CZECH SPORT AIRCRAFT	<h1>SERVICE BULLETIN</h1>	Czech Sport Aircraft a.s. Na Záhonech 212, 686 04 Kunovice Czech Republic office@czechsportaircraft.com	
		No.: SB-SC-039	Rev.: 1
		Date: 2017-09-20 Page: 1 of 6	Date: 2017-10-09

MODEL AFFECTED:	SportCruiser / PiperSport
SUBJECT:	Landing Light Replacement
AIRCRAFT AFFECTED:	All SportCruiser / PiperSport aircraft, as applicable
COMPLIANCE:	Apply this Service Bulletin when replacement of the landing light Trail Tech 4213-SX is needed

Figure 1 – Dismounting of the Original landing light Trail Tech 4213-SX

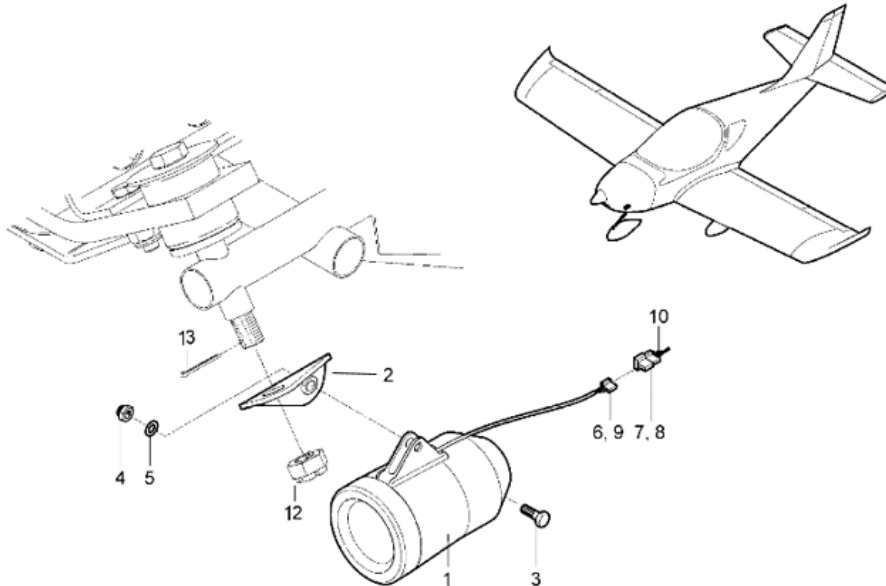
5. Remove the engine lower cowling (see the SC-AMM-1-0-00, the latest revision).
6. Disconnect the battery terminals.
7. Disconnect the Original landing light from the aircraft wiring system - cable with the connector (6, 9) from the wiring (7, 8, 10). See Figure 1 below.

8. Remove the Original landing light (1) with bracket (2) from the engine mount.
9. Screw back the castle nut (12) and secure with the new cotter pin (13). To eliminate the slackness use the washer (33).

Figure 2 – Mounting of the New landing light Trail Tech D112-SX

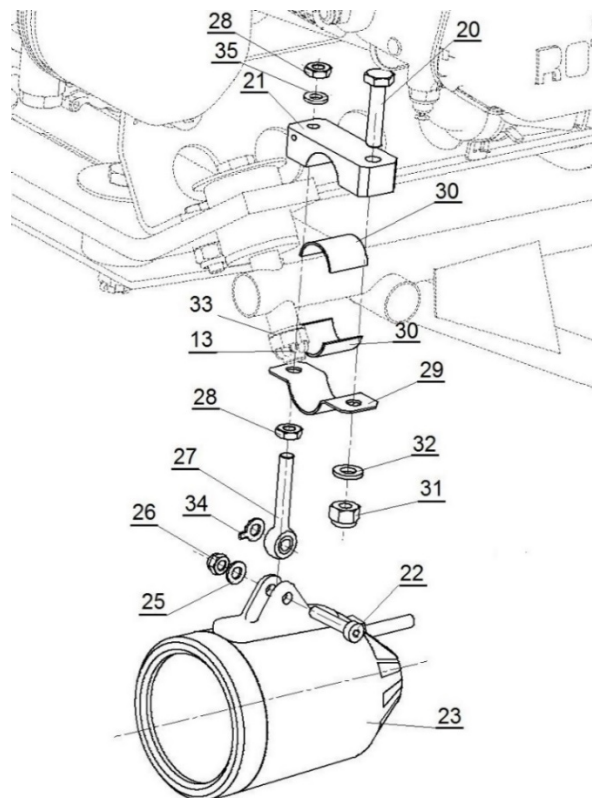
10. Install the New landing light (23) with the new holder (21, 29, 30) supplied by the Czech Sport Aircraft using connecting parts (20, 31, 32, 22, 25, 26, 27, 28, 35), see Figure 2.

11. If the gap between the light mounting (23) and the threaded eye (27) on the screw (22) is 0,5 mm or more, insert the washer (34) between the light mounting and the threaded eye. Tighten the screw (22) firmly.

Figure 3 – The New landing light position adjustment

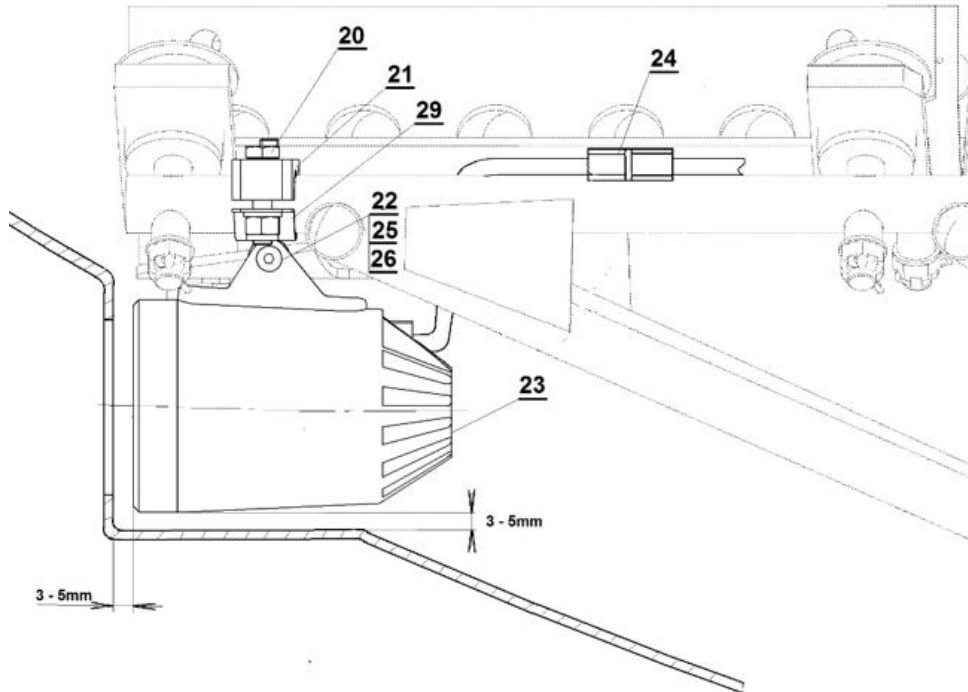
12. Interconnect the airplane connector (8) with the landing light connector (24), see Figure 1 and 3.
13. Install the engine lower cowling and check the landing light position – it must be adjusted so that the optical axis of the landing light passes through the middle of the engine lower cowling opening, see Figure 3 and 4. Use the parts (21, 29, 30) for adjustment.
Note: To reach the adjustment parts (21, 29, 30), the engine lower cowling has to be removed first. To check the adjustment, the engine lower cowling has to be installed first.

14. Once a correct landing light position is done, remove the engine lower cowling and secure the adjustment by tightening the nut (28) and connecting parts (20, 31, 32).
